**Transpecs**
Service Bulletin

BODY LOCK INFORMATION
Part No. 14295000368

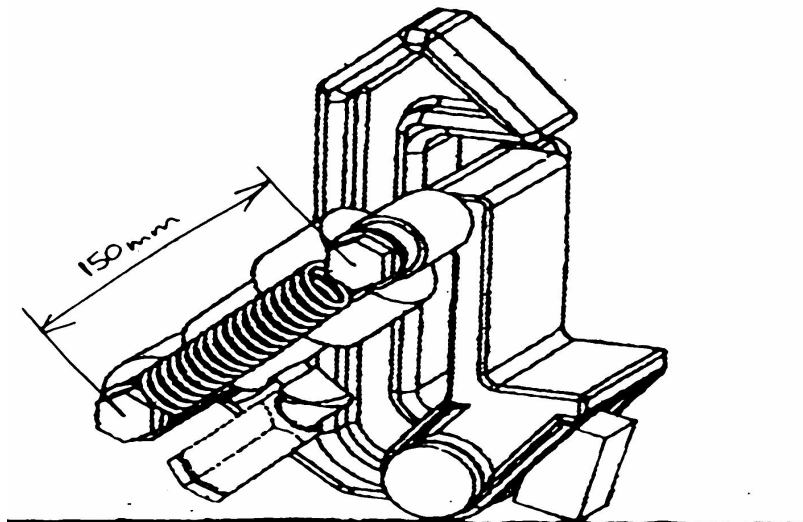
When installing the part as pictured please ensure the stop bolt is adjusted to limit the travel of the hydraulic cylinder to 150mm centres.

Failure to set this on installation may cause the cylinder to fail prematurely.
